Access Compliance Report Public Rights-of-Way (Curb Ramps)

Main Street: N/A Cross Street: SUERTE_ST Location: SW

ADA ID: RPRK211124140248 Ramp Type: Type 1 - Perpendicular Diagonal Initial Pass/Fail: Pass Overall Compliance: No Severity Score: 0

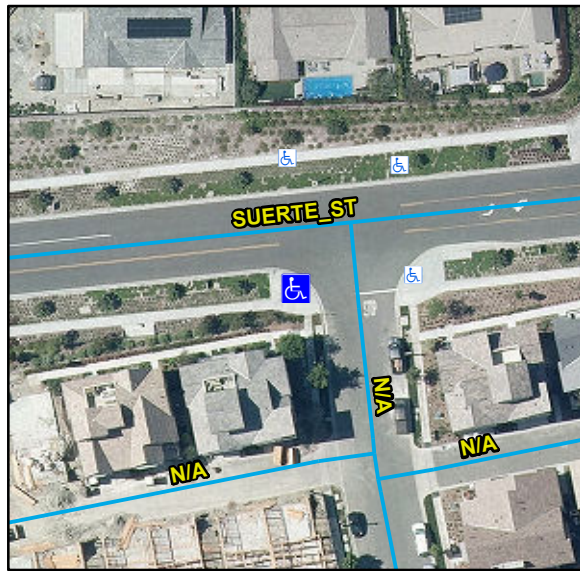
Remove & Replace Curb Slope. Remove & Replace Gutter.

R304.2.2, R304.5.3, STD 1115
